## **OAK FOREST PLACE SUBDIVISION**

APPLICATION NUMBER 15 DATE June 18, 2009

REQUEST Subdivision

# DETAIL SITE PLAN

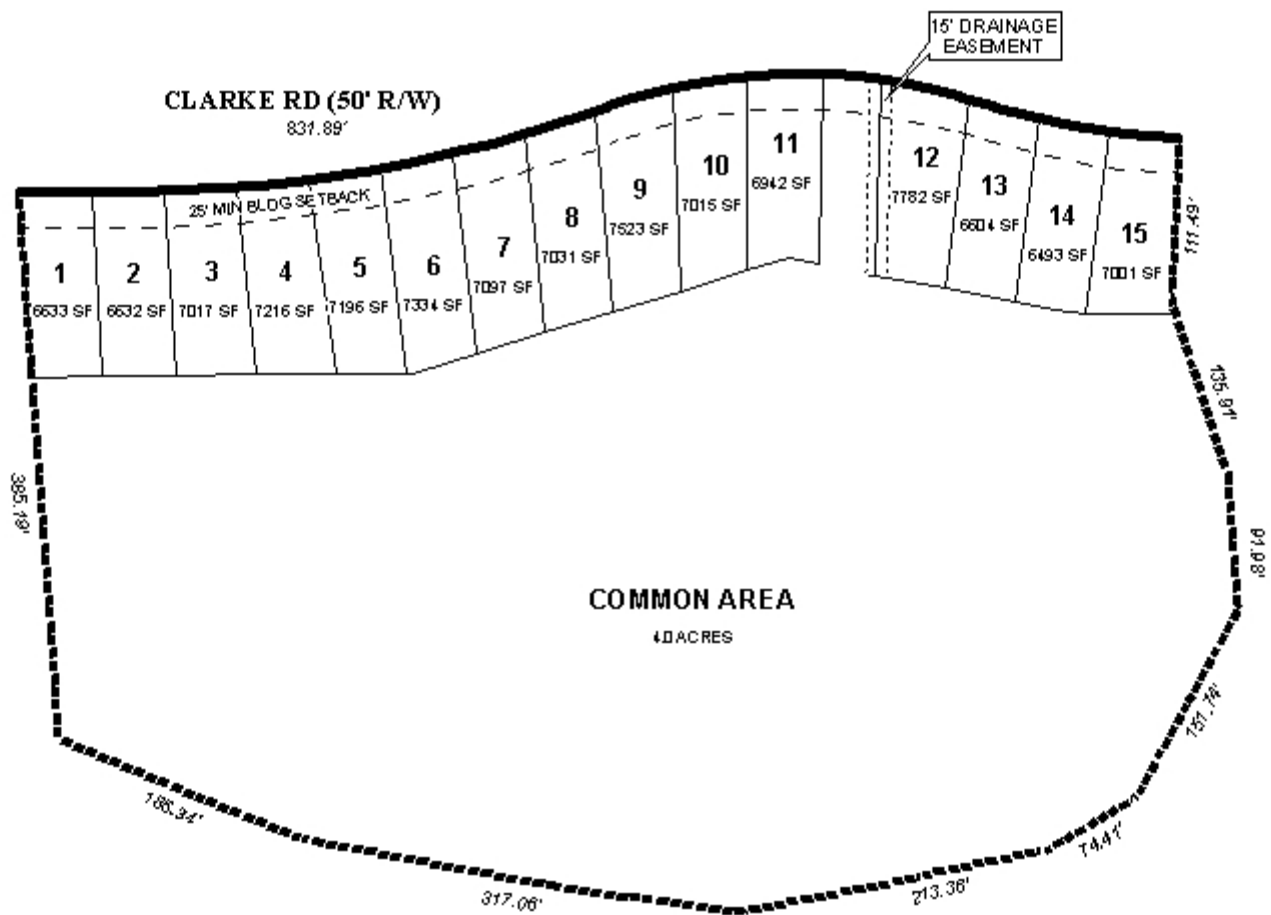
The plat illustrates the proposed 15 Lot / 9.5± acre subdivision which is located on the South side of Clarke Road, 156'± East of Dawes Road. The applicant states that the subdivision is served by public water and sanitary sewer systems.

Of the 15 proposed residential lots, 11 fall below the minimum lot size required by Section V.D.2. of the Subdivision Regulations: the smallest proposed lot is 6,493 ± square feet. It should also be pointed out that 14 of the lots will be less than 60 feet wide: the narrowest lot will be approximately 50 feet wide, thus a waiver of Section V.D.2. will be required in order to approve the subdivision. Earlier approved phases of the overall subdivision included smaller than required lots, however, the applications at the time claimed innovative design. No claim of innovative design accompanied this application, however, approval as proposed would be consistent with the existing subdivision and the 2006 approval.

The site fronts Clarke Road, a minor street with adequate right-of-way. While Clarke Road is a minor street, it serves as one of the major entry roads for the overall subdivision, thus access management is a concern. Each lot should be limited to one curb-cut, as should the proposed common area, with the size, design and location of all curb-cuts to be approved by the Mobile County Engineering Department, and to conform to AASHTO standards.

Regarding the proposed 4 ± acre common area, a 40-foot wide access strip from Clarke Road is proposed. National Wetlands Inventory map data available to staff indicates that the common area is considered wetlands, however, the once forested site was almost completely cleared by

2002, thus any remaining wetlands on the site would likely occur in the remaining vegetated strip that varies from 30 to 180  $\pm$  feet in width along the southern boundary of the common area. It should also be pointed out that aerial photos show that the cleared portion of the common area appears to be used for the dumping of soil or spoils, and thus is not providing any practicable compensating open space to make up for the reduce lot sizes. Regardless of the status of the common area, a note should be placed on the final plat, if approved, stating that maintenance of the common area will be the responsibility of the property owners.

With a waiver of Section V.D.2. for lot size and lot width, this application is recommended for Tentative Approval, subject to the following conditions:

- 1) Compliance with the Mobile County Flood Damage Prevention Ordinance;
- 2) Compliance with the storm water detention and drainage facility requirements of the City of Mobile storm water and flood control ordinances, and submittal of a letter from a licensed engineer certifying that the design complies with the storm water detention and drainage facility requirements of the City of Mobile storm water and flood control ordinances prior to the issuance of any permits;

- 3) Placement of a note on the final plat stating that each lot and the common area are limited to one curb-cut each, with the size, design and location to be approved by Mobile County Engineering, and to comply with AASHTO standards;

- 4) Placement of a note on the final plat stating that maintenance of the common area is the responsibility of property owners;
- 5) Placement of a note on the final plat stating that development of the site must be undertaken in compliance with all local, state and federal laws pertaining to wetlands;

- 7) Depiction of the minimum building setback line and lot size information, as depicted on the preliminary plat; and
- 8) Placement of a note on the final plat stating that lots which are developed commercially and adjoin residentially developed property must provide a buffer, in compliance with Section V.A.7. of the Subdivision Regulations.
